SERVICE BULLETIN INFORMATION SHEET

MODEL BD-100-1A10 (CH-350)

**MODIFICATION – VOICE RECORDER SYSTEM –
INTRODUCTION OF THE RECORDER INDEPENDENT POWER SUPPLY (RIPS) FOR
THE COCKPIT VOICE RECORDER (CVR) OPTION (C23-511)**

Service Bulletin No.: 350-23-009 **Issue:** Rev. 03 **Dated:** Oct 30/2018

K1005357461 – Kit – RIPS Installation
(Sheet 1 of 1, Rev. C)

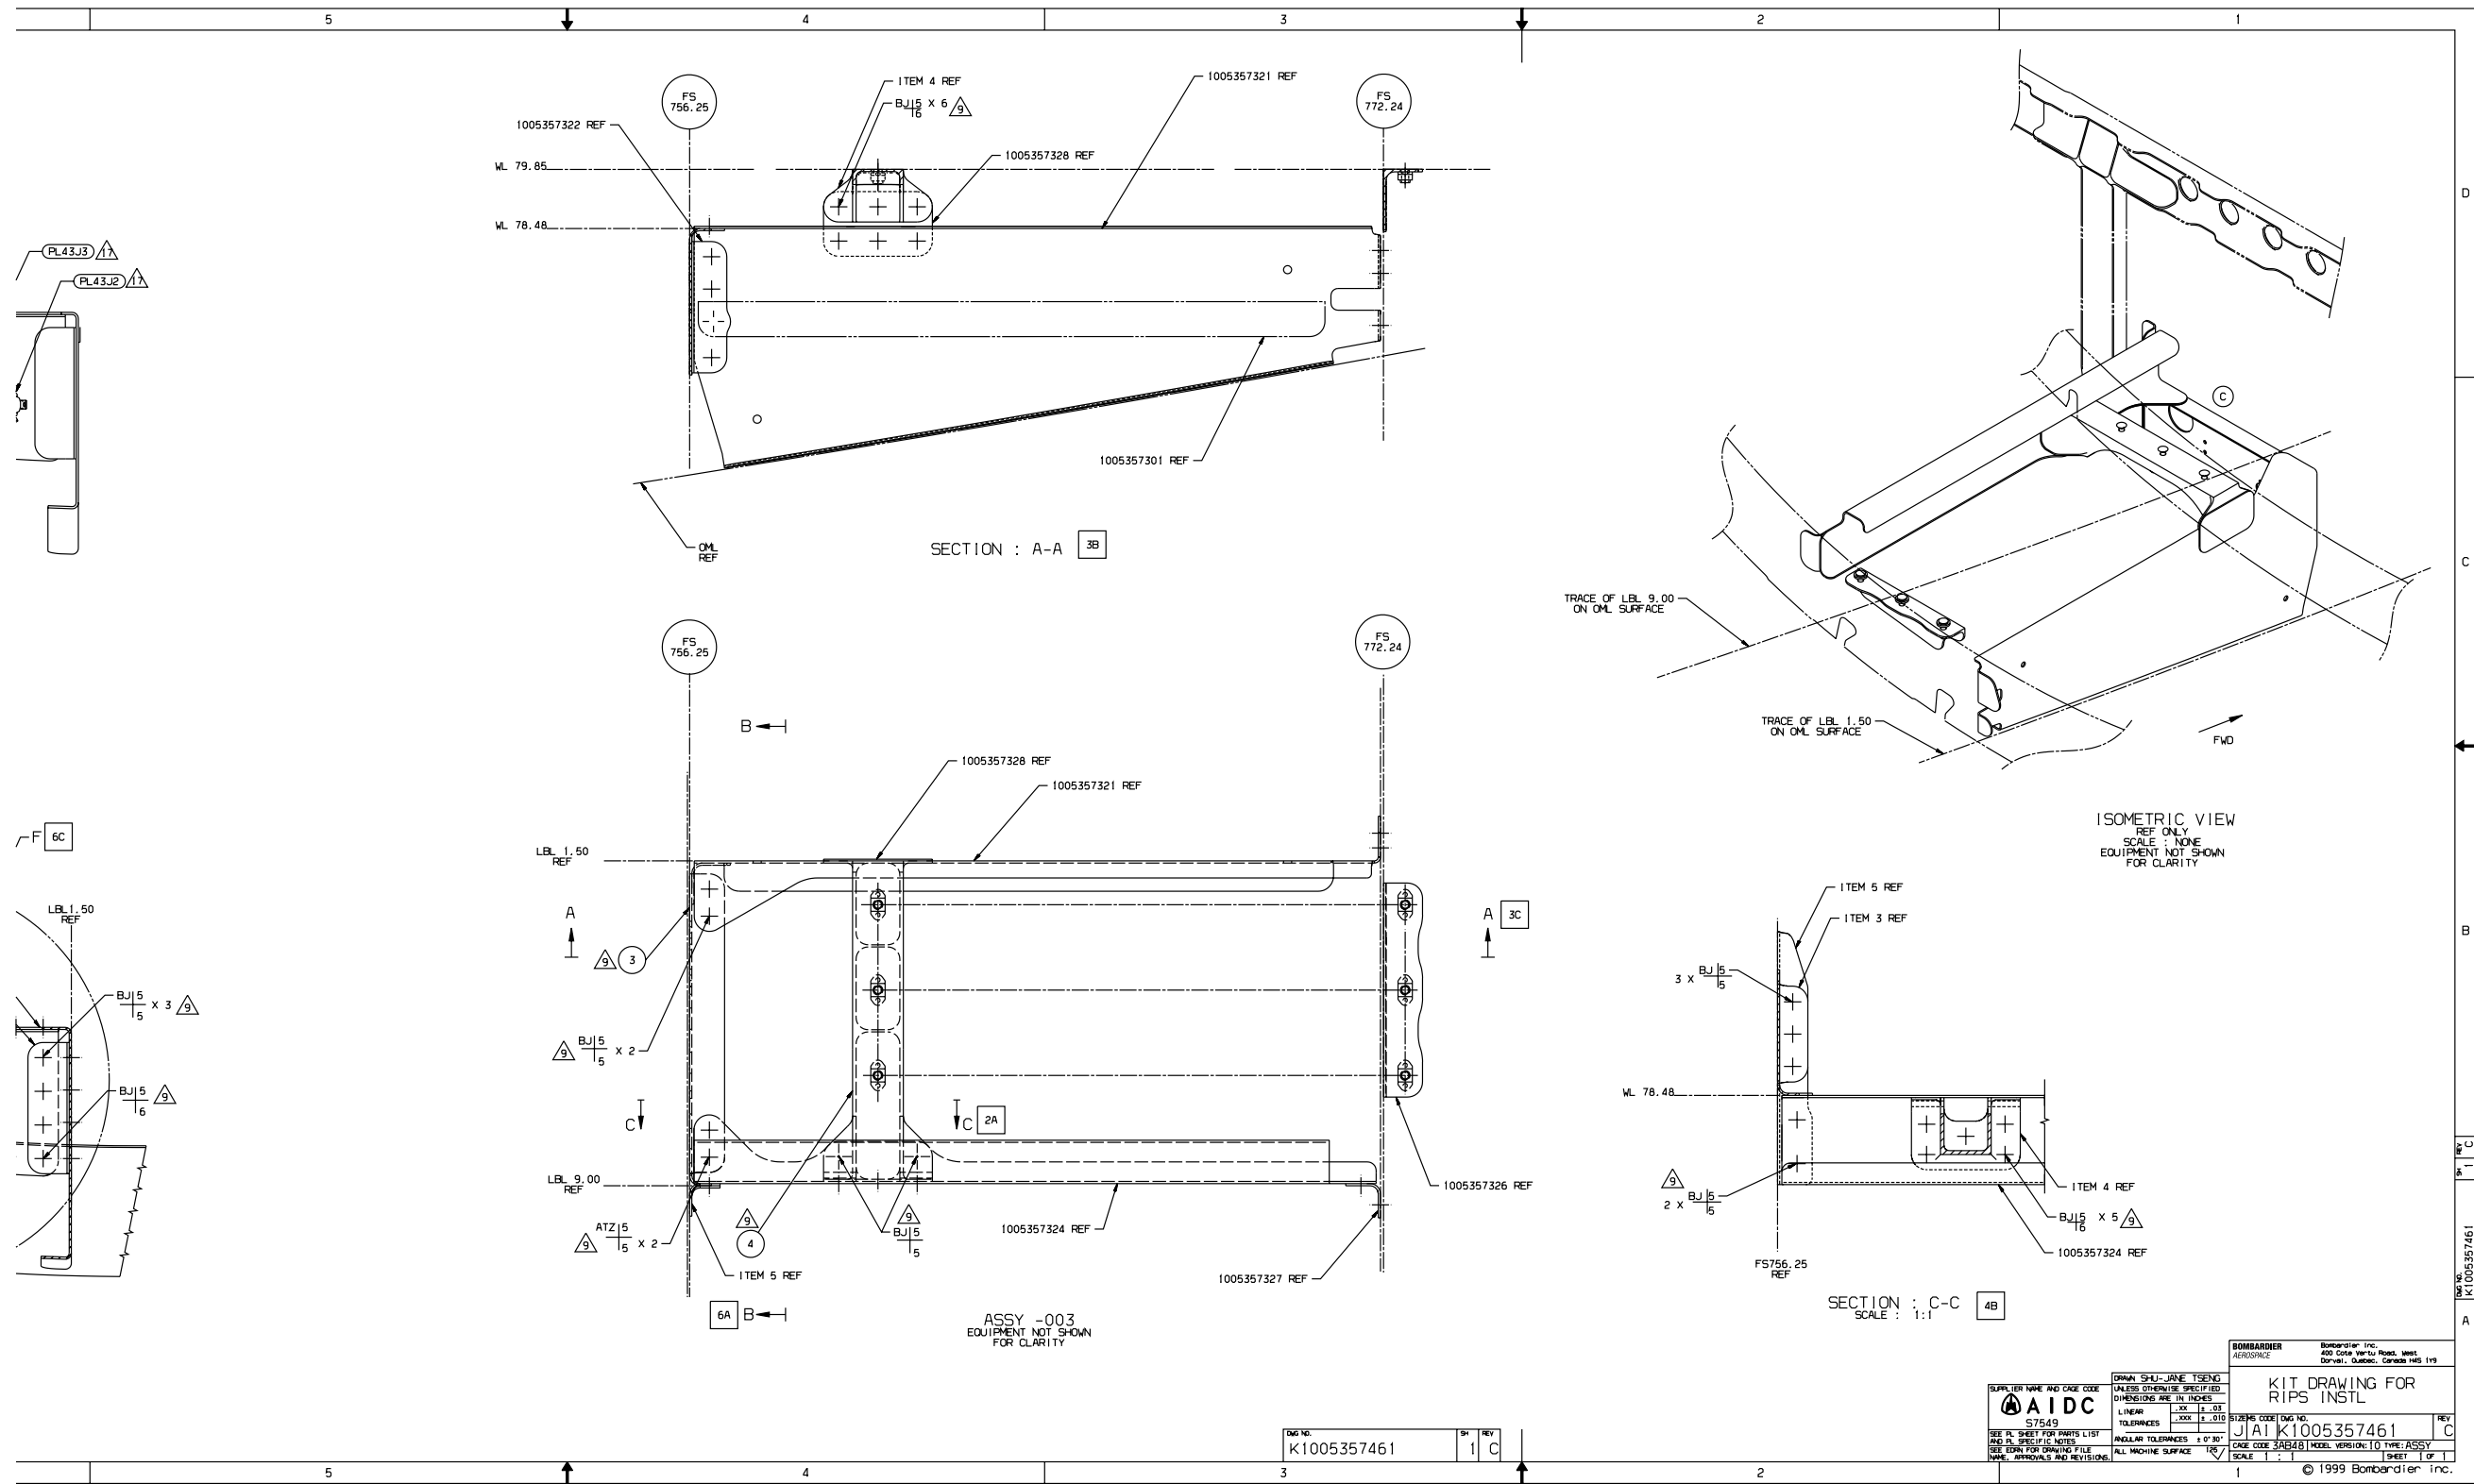
- (1) Disassemble and discard existing CVR mounting tray support structure as given in the attached kit drawing and as follows:

- (a) Remove the fasteners that attach the web, Part No. 1005357323-001, to the frame at FS 756.25. Refer to SRM 51-42-08.
- (b) Remove the fasteners that attach the web, Part No. 1005357323-001, to angle Part No. 1005357322. Refer to SRM 51-42-08.
- (c) Remove the fasteners that attach the channel, Part No. 1005357324-001, to the frame at FS772.24. Refer to SRM 51-42-08.
- (d) Remove the fasteners that attach the beam, Part No. 1005357325-001, to the intercostal Part No. 1005357321-001. Refer to SRM 51-42-08.
- (e) Remove the support structure from the aircraft.
- (f) On a work bench, disassemble the beam, Part No. 1005357325-001 and the web, Part No. 1005357323-001, from the channel Part No. 1005357324-001. Refer to SRM 51-42-08.
- (g) Keep the channel, Part No. 1005357324-001, for later installation.

- (2) Rework beam, Part No. 1005352910, as follows:

- (a) Trim the beam, Part No. 1005352910, as shown on sheet 1, view E.
- (b) Drill two 0.3125 (5/16) in (7.9375 mm) holes in beam, Part No. 1005352910, as shown in section G-G.

NOTE: These two holes are made to give easier access to the two top bolts for the removal/installation of the ULD in service.

- (3) Install CVR mounting tray support-structure as follows:

- (a) Locate the web, Part No. 1005357462-003, as shown in section B-B.
- (b) Transfer drill existing holes, make sure to maintain the minimum required edge distance and attach temporarily. Refer to SRM 51-40-04.
- (c) Position the bracket, Part No. 1005357464-001S, as shown in section B-B and attach temporarily with clamps.
- (d) Drill the 0.098 in (2.490 mm) pilot holes from the web, Part No. 1005357462-003, through the bracket, Part No. 1005357464-001S and from the bracket, Part No. 1005357464-001S, through the frame at FS756.25 as shown in section B-B.
